SUBJECT: **Scott's Seafood Restaurant, Jack London Square, Oakland, Alameda County**
(For Board consideration on April 6, 2015, Second Pre-Application Review)

**Scott's Restaurant
Jack London Square
Public Pavilion Modifications and
Public Access Enhancements**

SUBJECT: Approved Minutes of April 6 2015 BCDC Design Review Board Meeting

SHEET NUMBER:
A.3.1

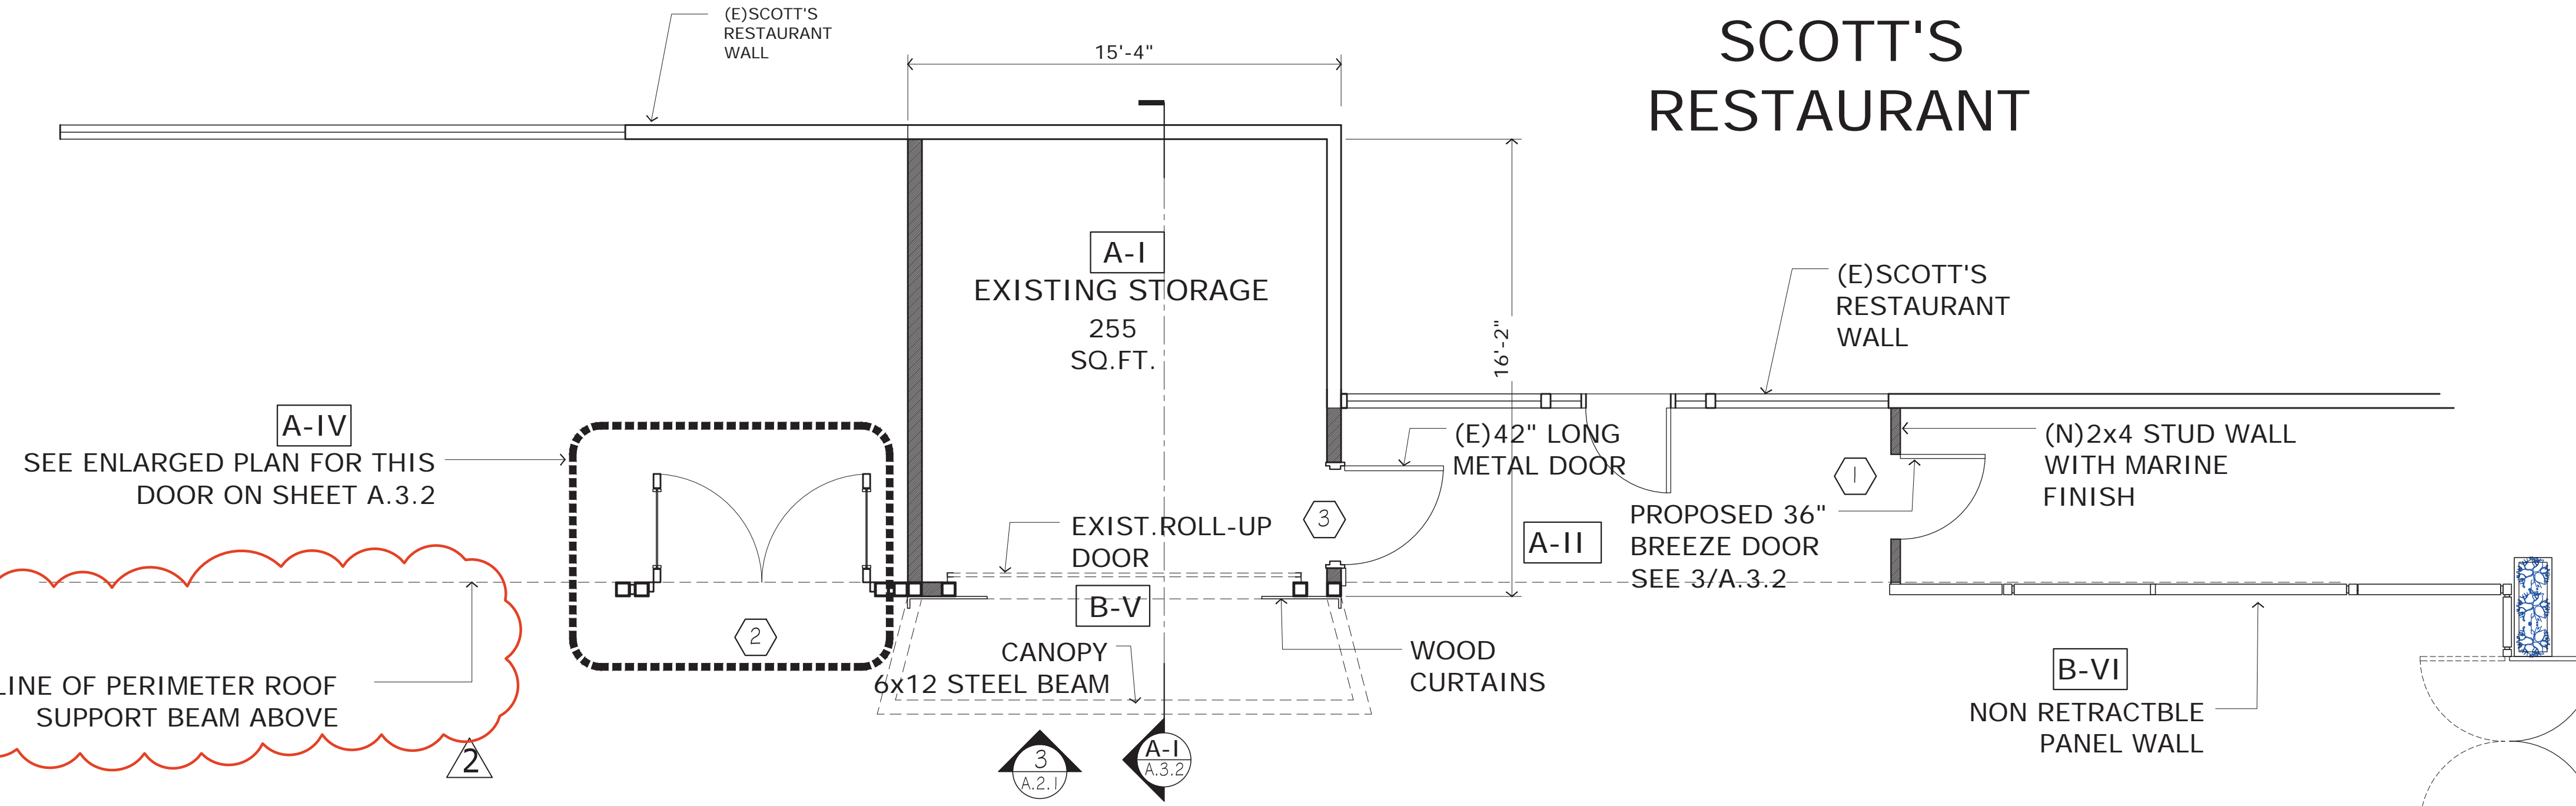
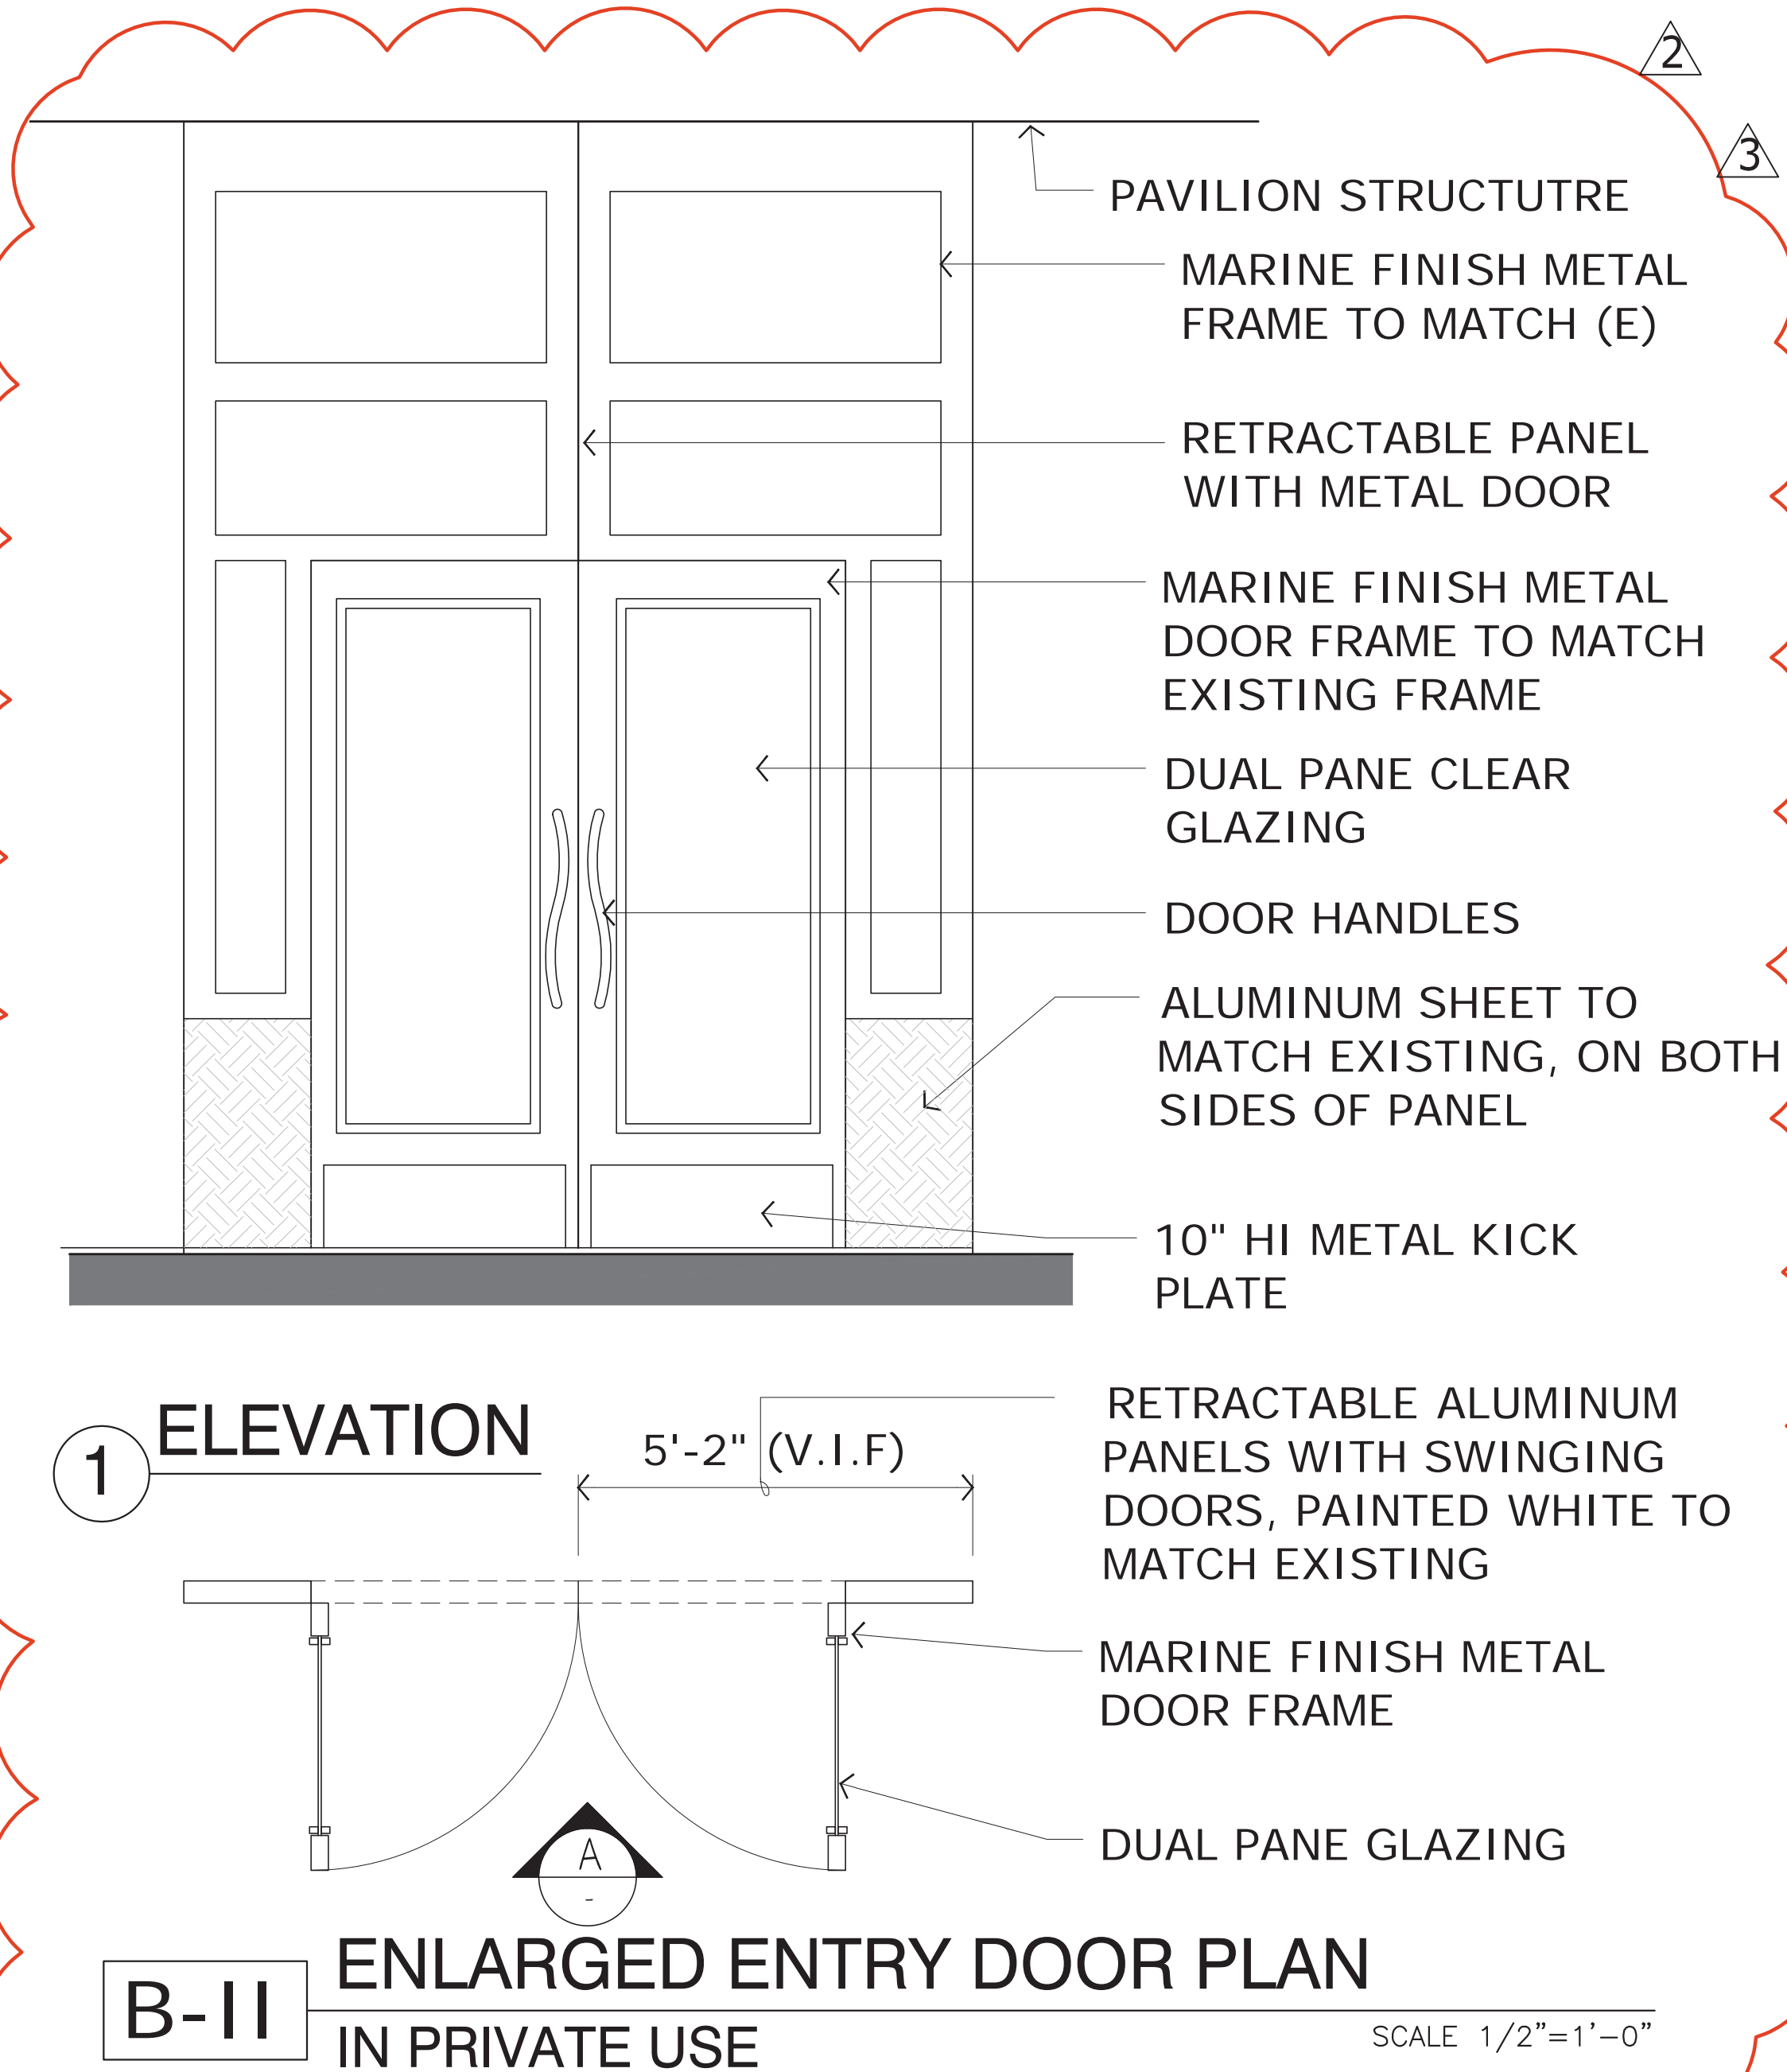
Ms. Alschuler asked which portions of the panels shown on Sheet A.3.1 were transparent and which were translucent. This was explained by reviewing the plans, which depict where the windows are located.
